Supplement to EMC Test Report for Motorola portable cellular phone (FCC ID IHDP56JX2)

Summary of FCC request for additional information

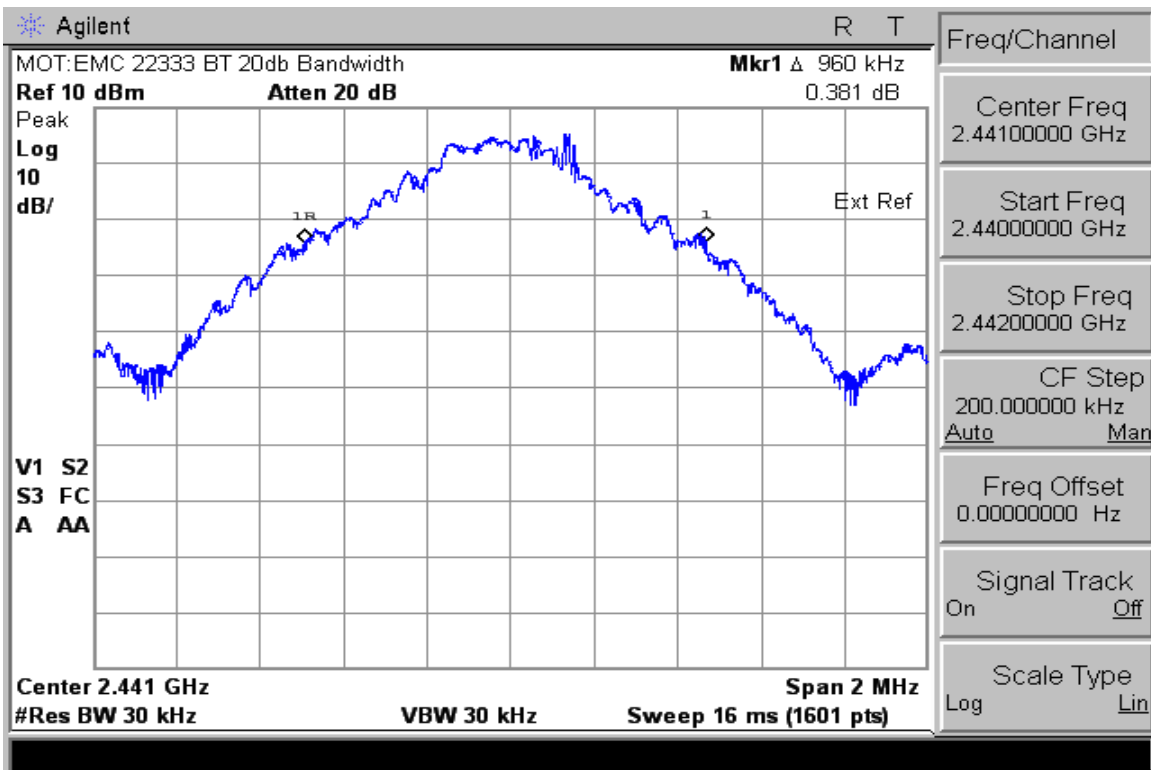
3. On p.13/27 of the BT report, it appears that the (right hand) marker is not set at the widest possible 20 dBc point on the emission. Please remeasure, setting the markers at the widest possible 20 dBc points and resubmit that data. Please note that if the 20 dBc bw is > 1 MHz, the output power will also have to be remeasured (a RBW = 1 MHz was used).
4. Please confirm that the CDMA 800 EvDO (FTAP) output power listed for channel 777, shown on p.7/44 of the EMC report, is a typo. Please revise and resubmit.

3. The Bluetooth 20dBc BW was remeasured and the new plot is attached below.
